RE: Preliminary Plan No. 120210140  
8001 Wisconsin Avenue

RE: 8001 Wisconsin Avenue  
Traffic Impact Study Review

Re: **COMBINED STORMWATER MANAGEMENT  
CONCEPT/SITE DEVELOPMENT  
STORMWATER MANAGEMENT PLAN** for  
8001 Wisconsin  
Preliminary Plan #: 120200210  
SM File #: 285810  
Tract Size/Zone: 1.89 Ac/CR  
Total Concept Area: 2.18 Ac  
Lots/Block: P1-3.7,9,14,21,23,25,26,27,28/ 5  
Parcel(s): N/A  
Watershed: LRC

**DATE:** 16-Dec-21  
**TO:** Ghassan Kouri - khouri@vika.com  
VIKA, Inc  
**FROM:** Marie LaBaw  
**RE:** 8001 Wisconsin Ave  
120200210

FIRE  
DEPARTMENT  
ACCESS

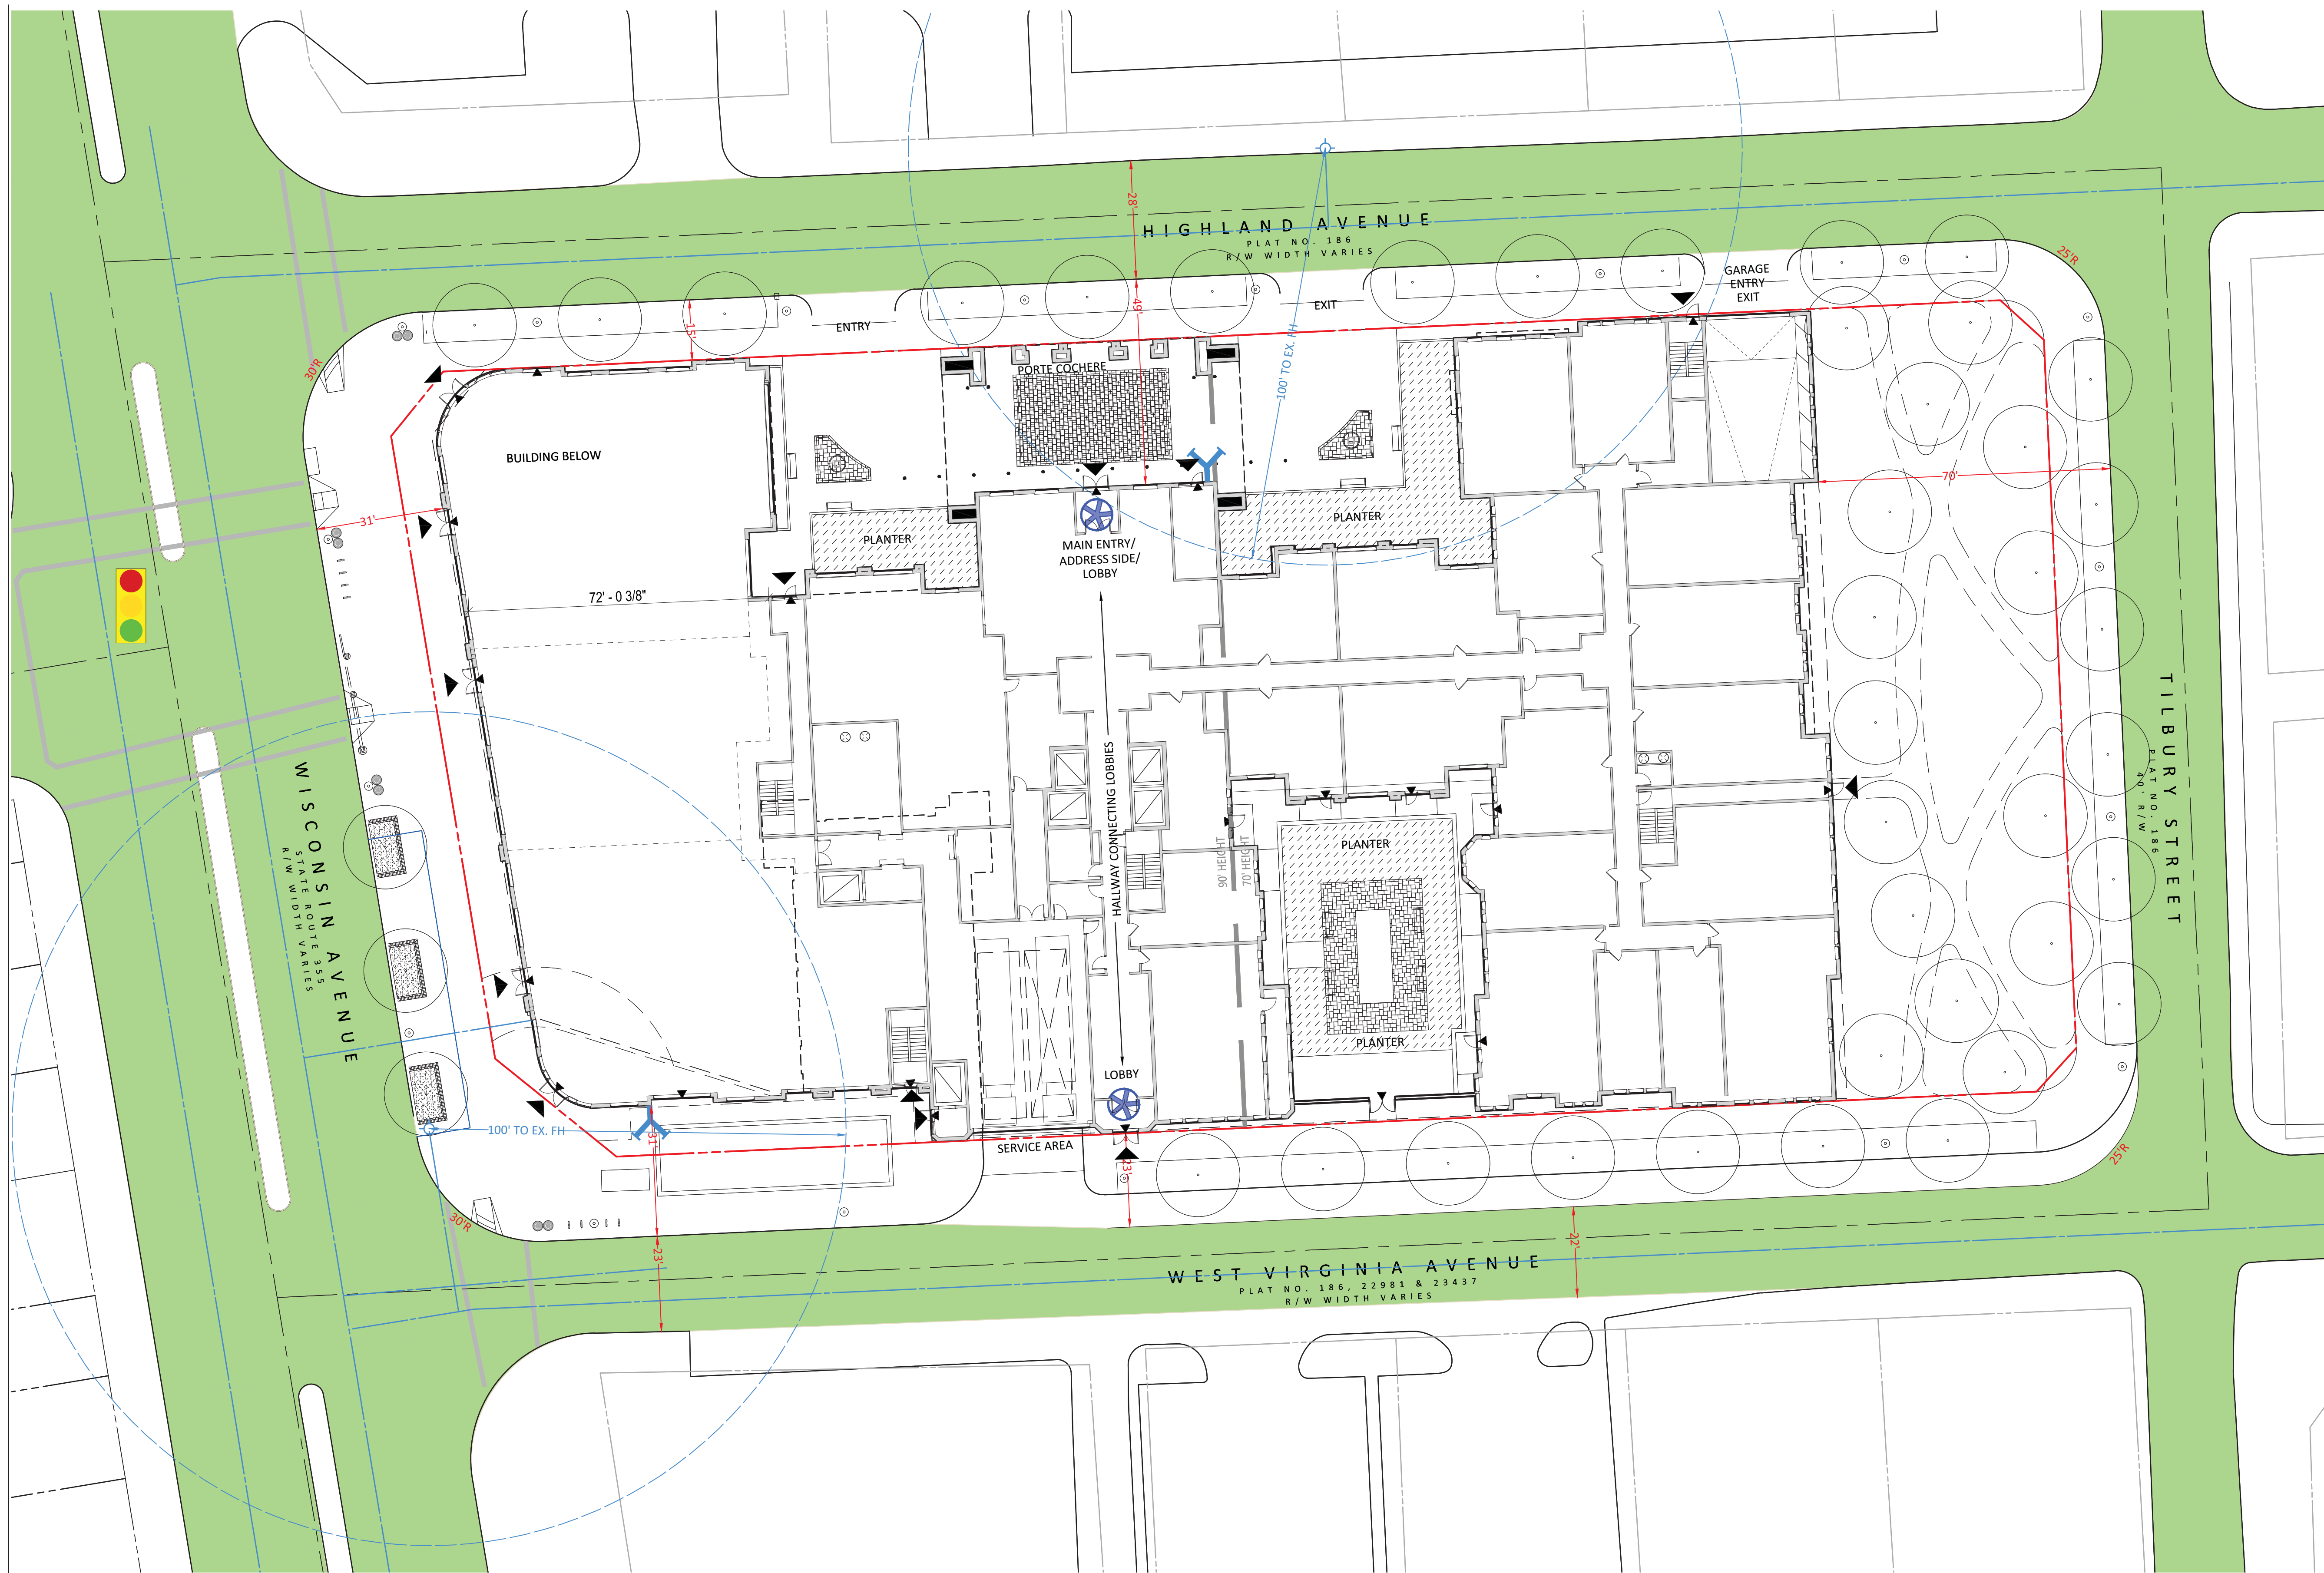
\*\*\* Base building must be addressed off Highland Ave \*\*\*
